Project: MU/Patient Care Tower-1230- MRI Room

Subject: Addendum No. 1

ADDENDUM #1

TO CONTRACT DOCUMENTS FOR: Project #CP245321 – Patient Care Tower – T1230 MRI Room

4 LEVEL 1 - FLOOR PLAN - POWER ENLARGED ELEC PT1012
1/8" = 1'-0"

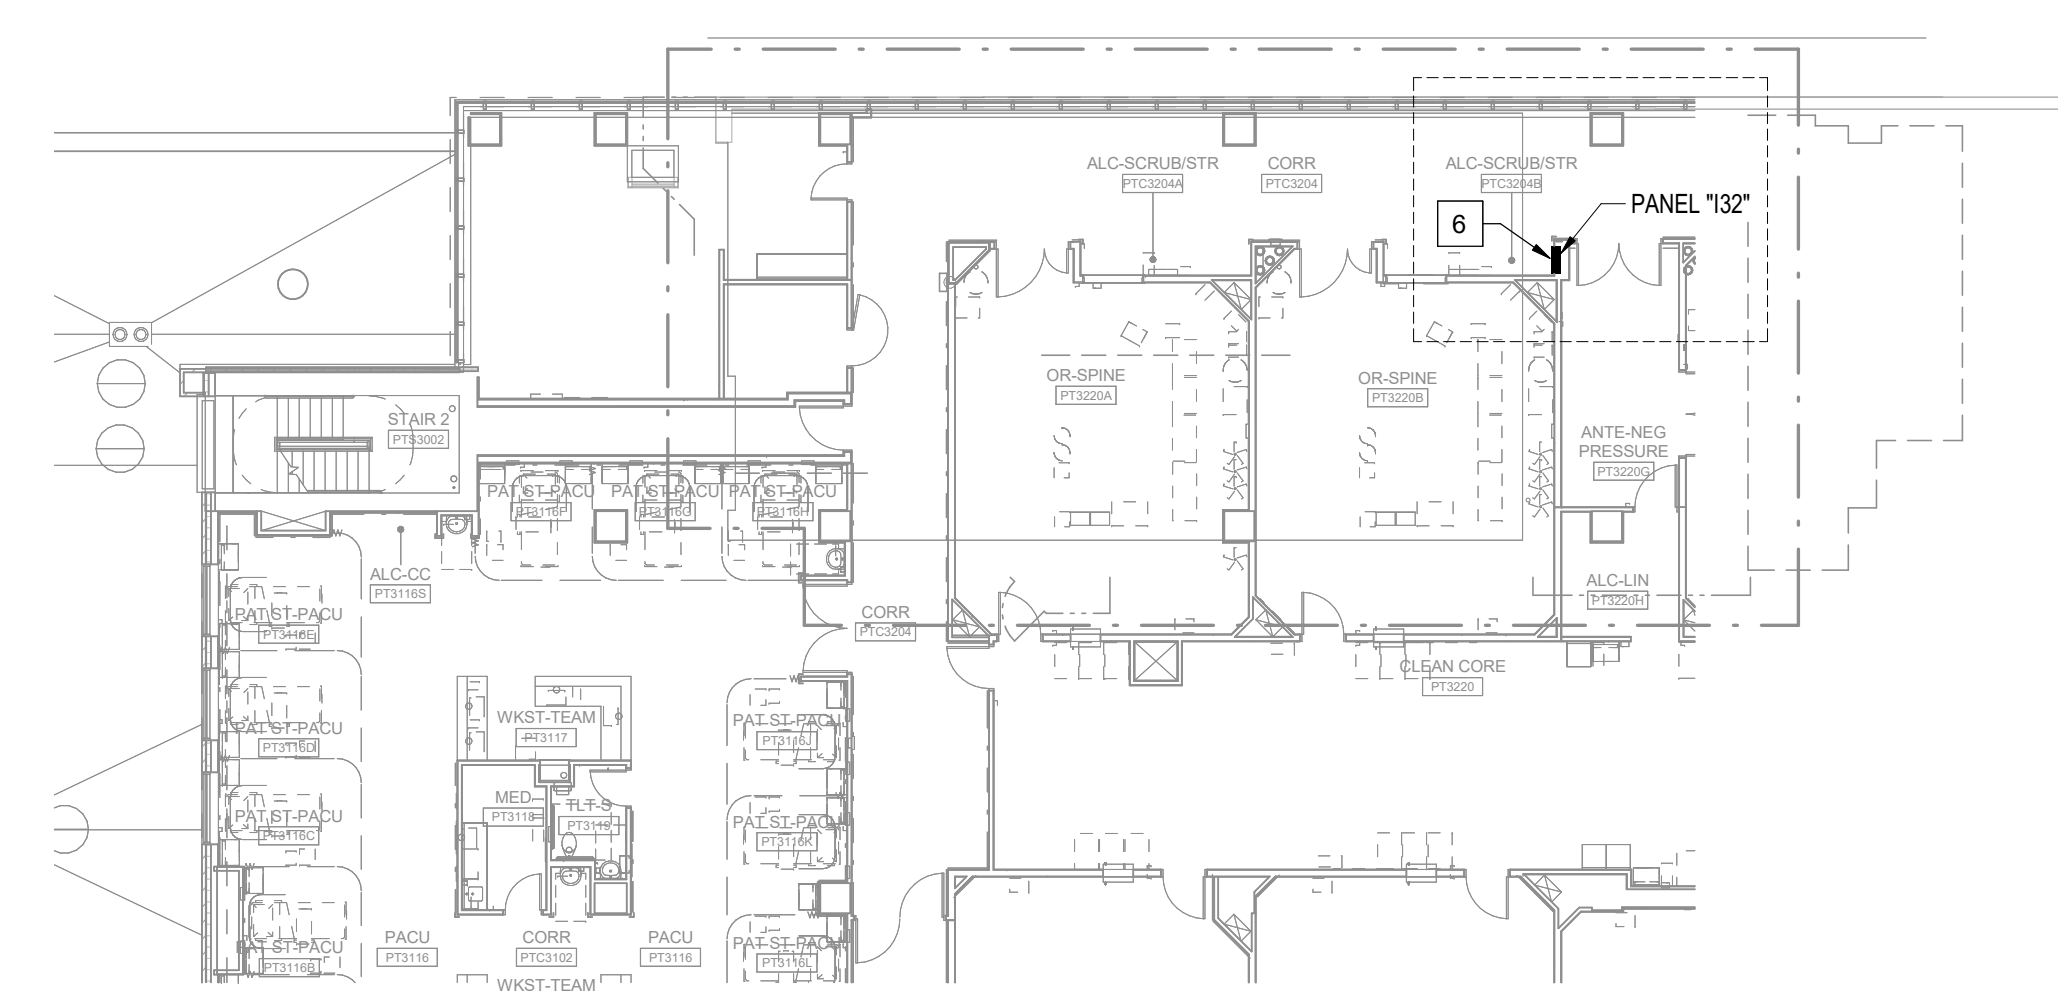
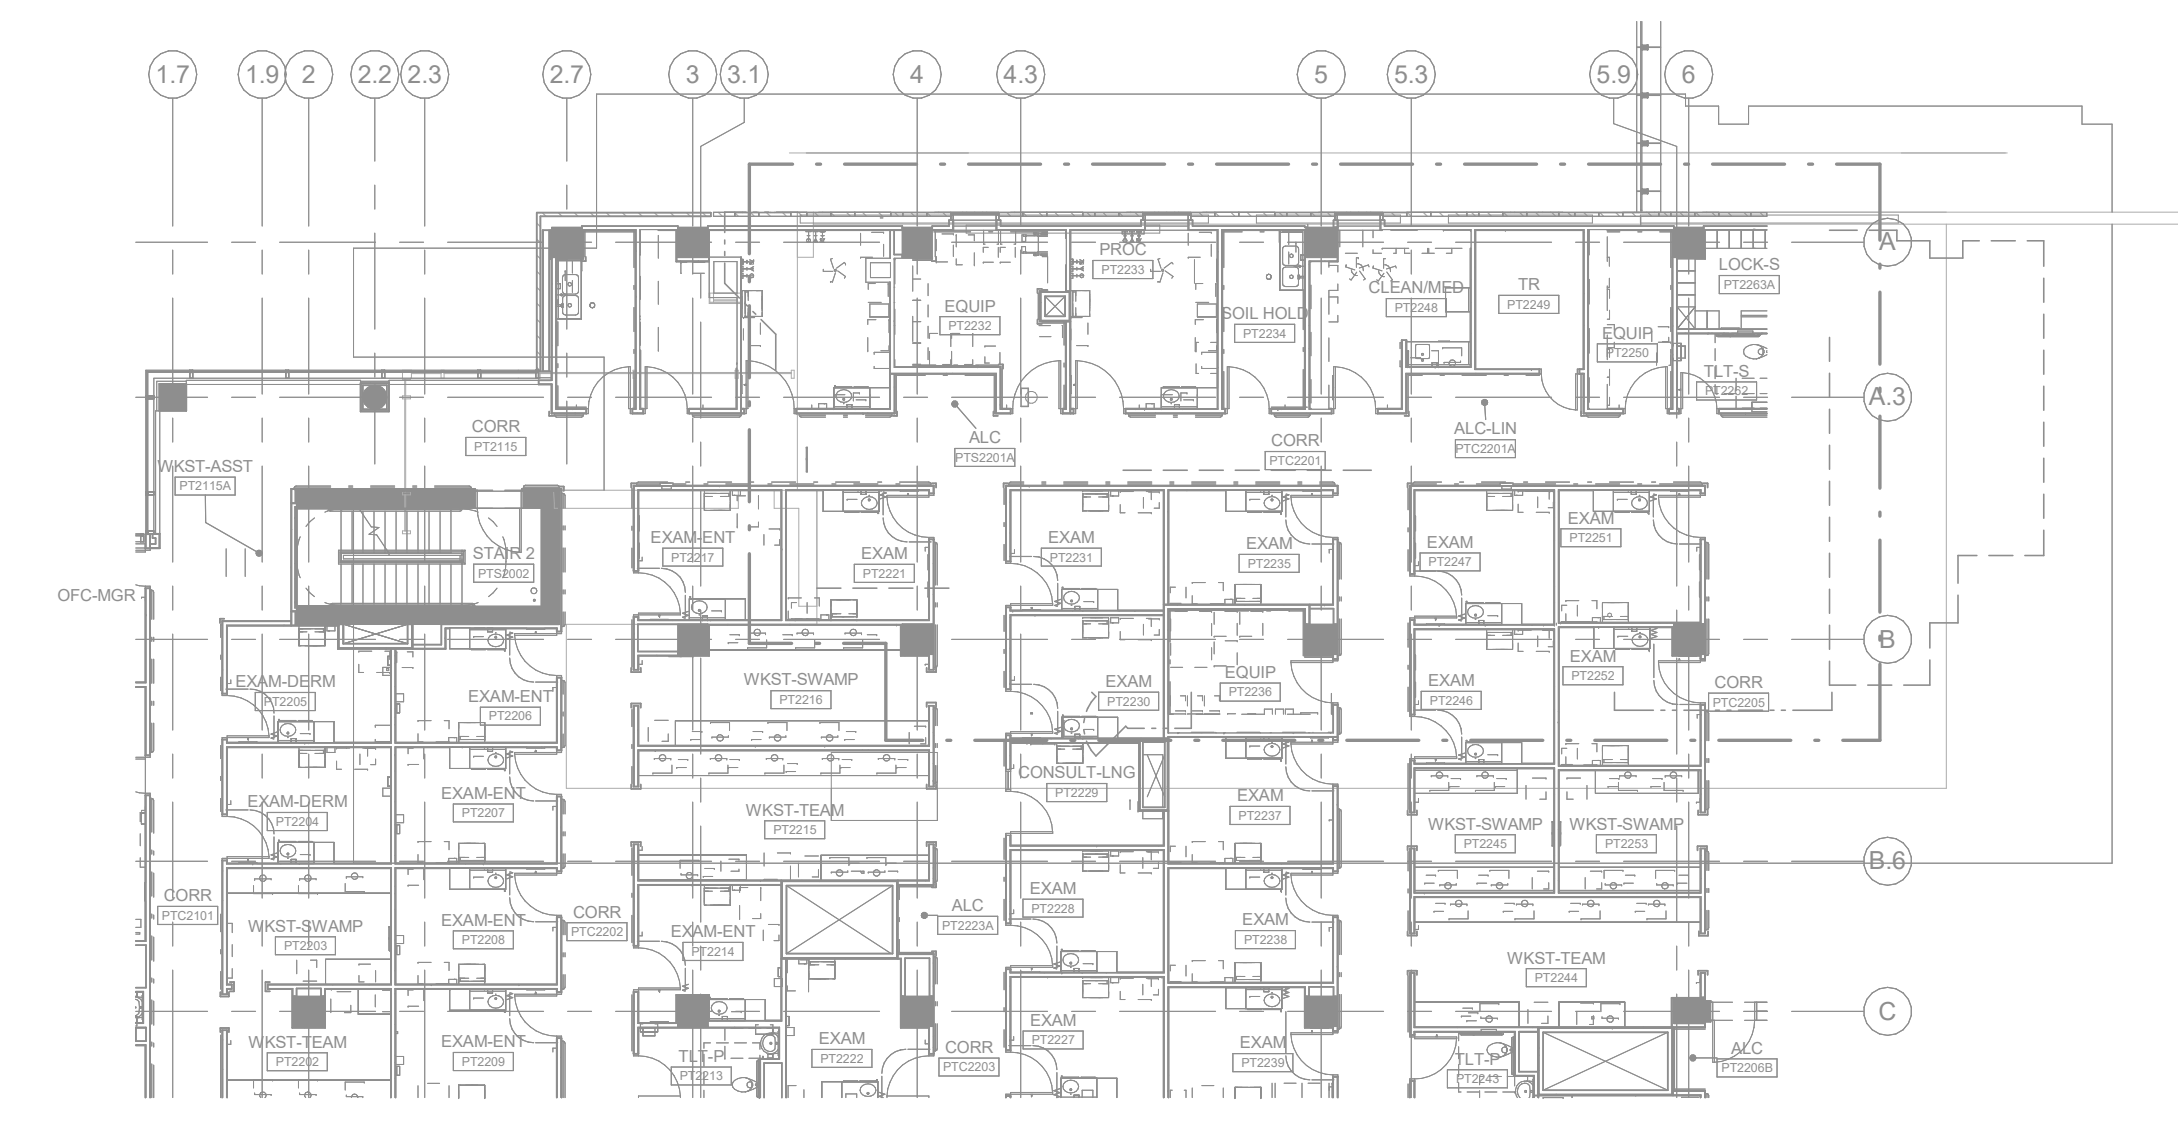
- 1) E0.1 – Electrical Legend
 - a. **REMOVED/CLEANED** unused legend items.
- 2) E0.2 – Electrical Key Plan
 - a. **ADDED** conduit routing on drawings for clarification purposes.

1 Level 1 - CEILING PLAN - LIGHTING DEMO
 1/4" = 1'-0"

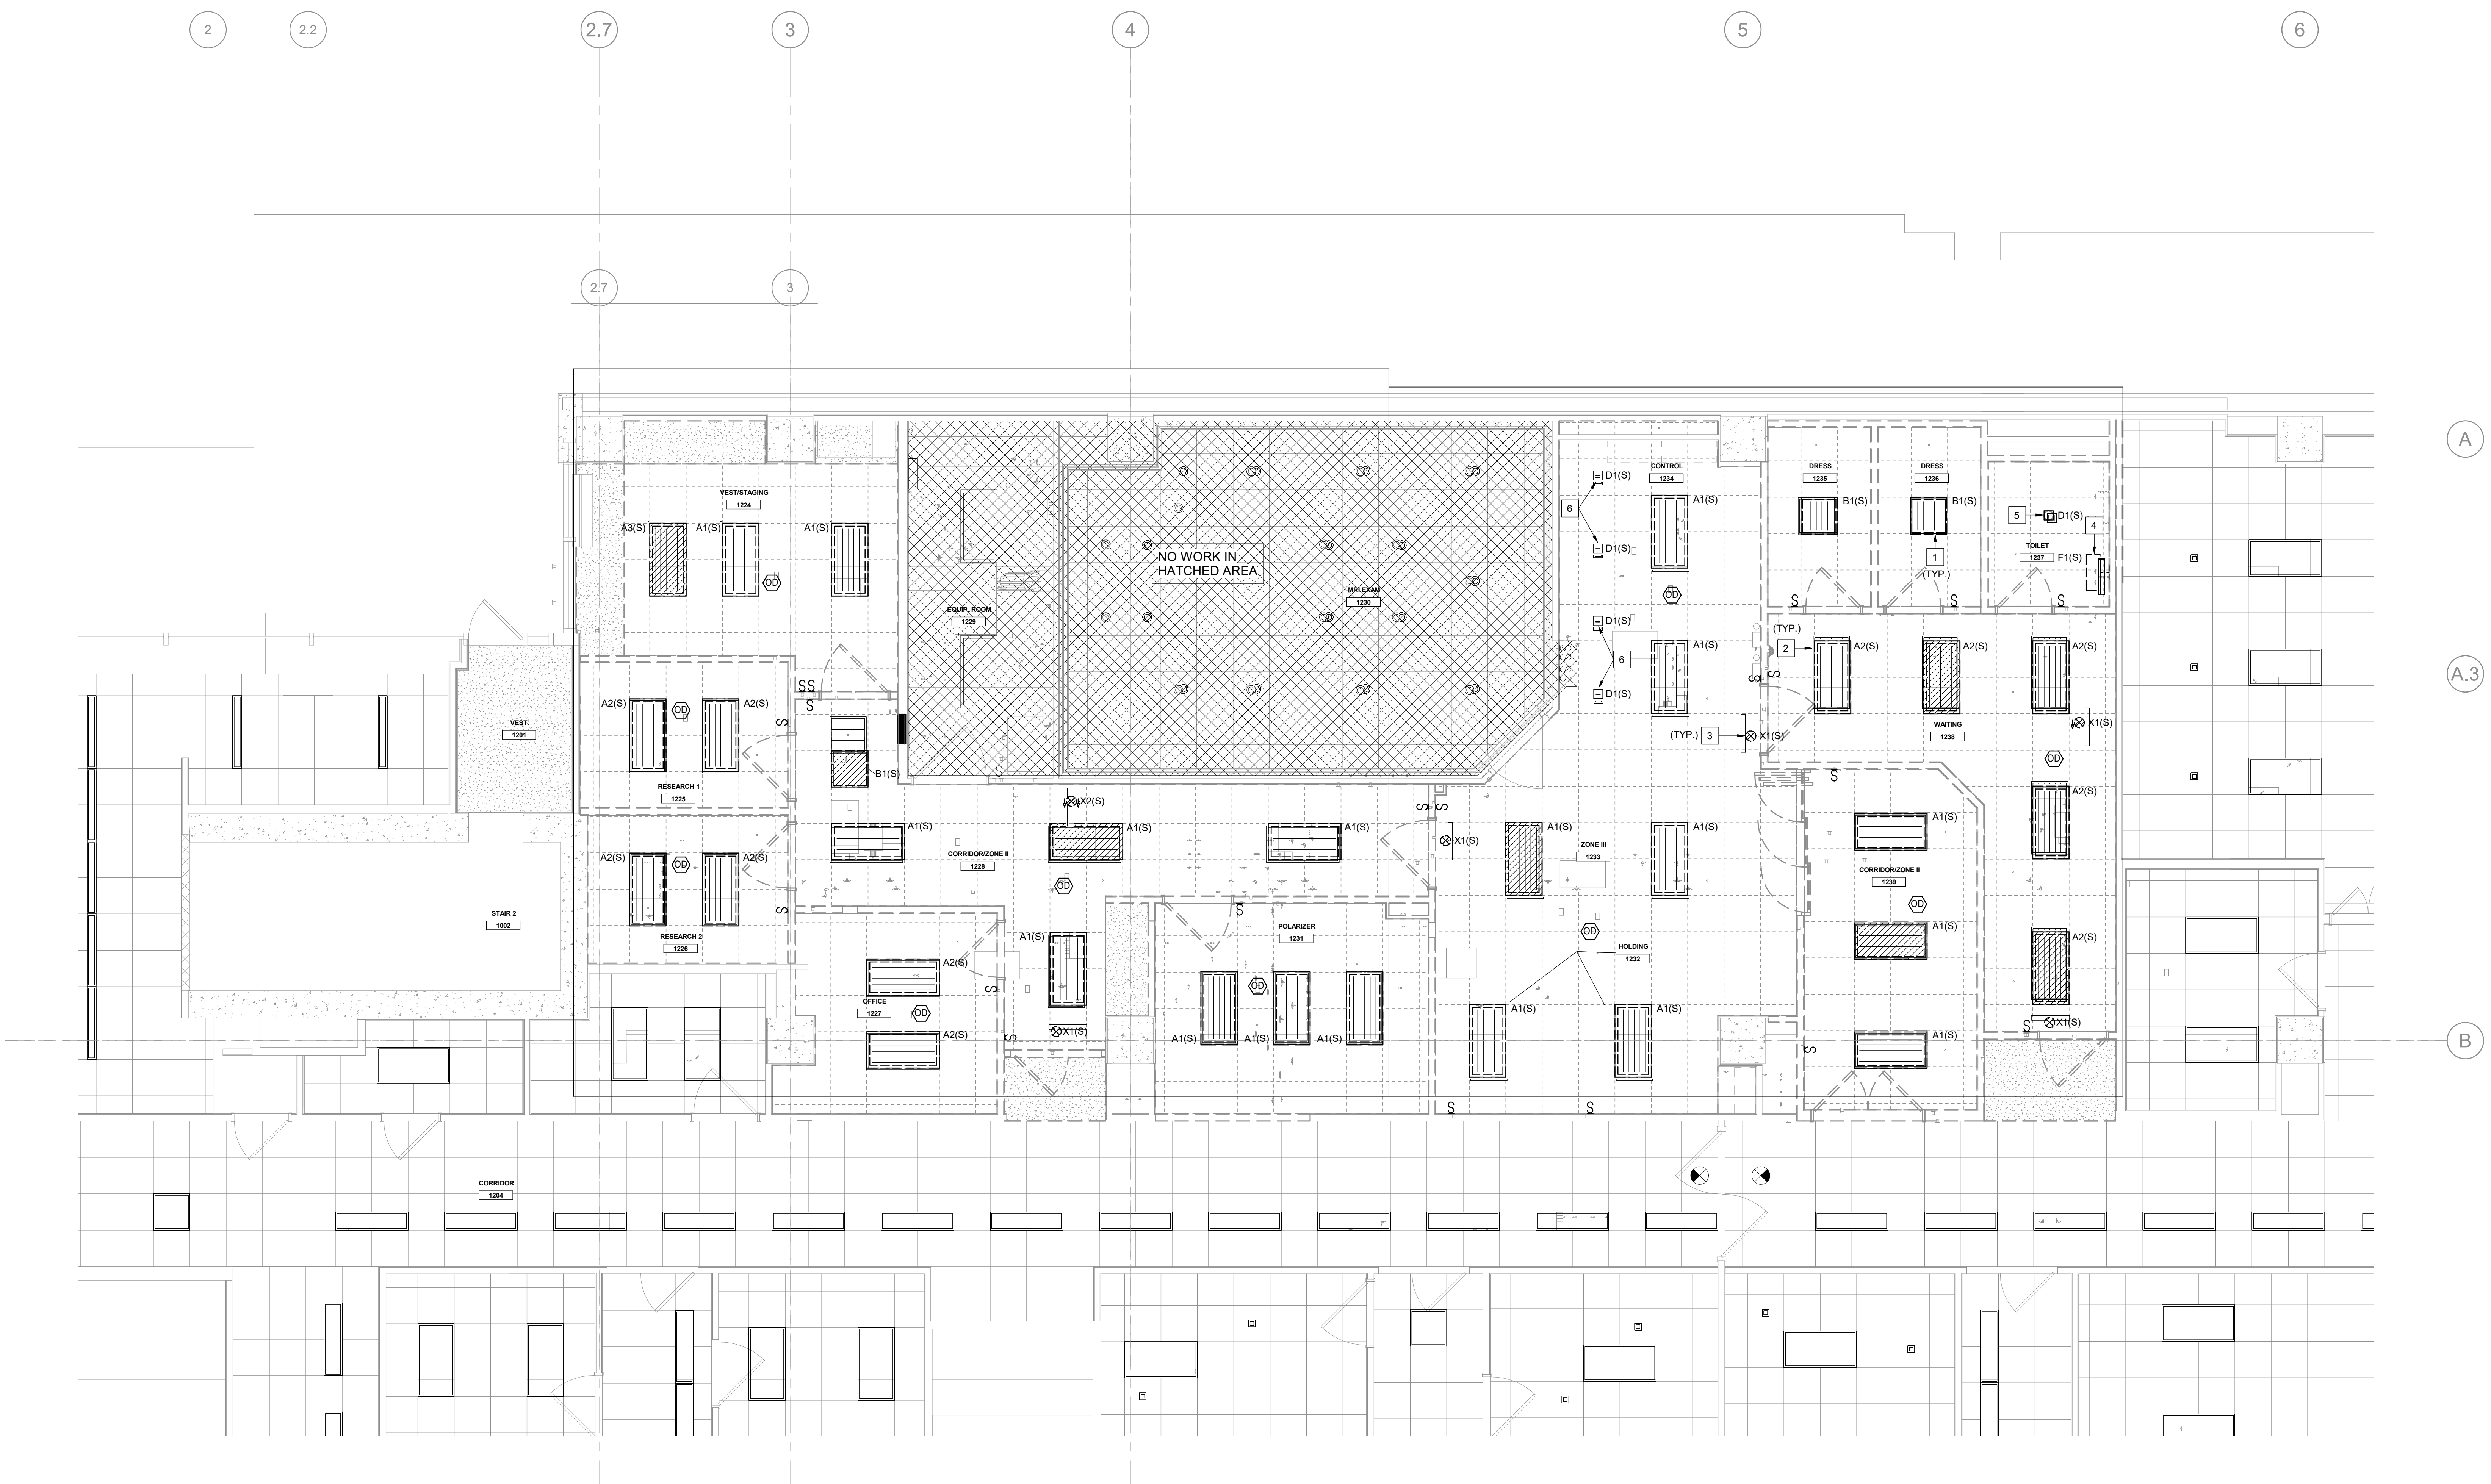
- 3) E1.1 – Fire Alarm First Floor Demo Plan
 - a. **REVISED** general notes C & D.
- 4) E1.2 – Lighting First Floor Demo Plan
 - a. **REVISED Plan notes 1, 4 & 5.**
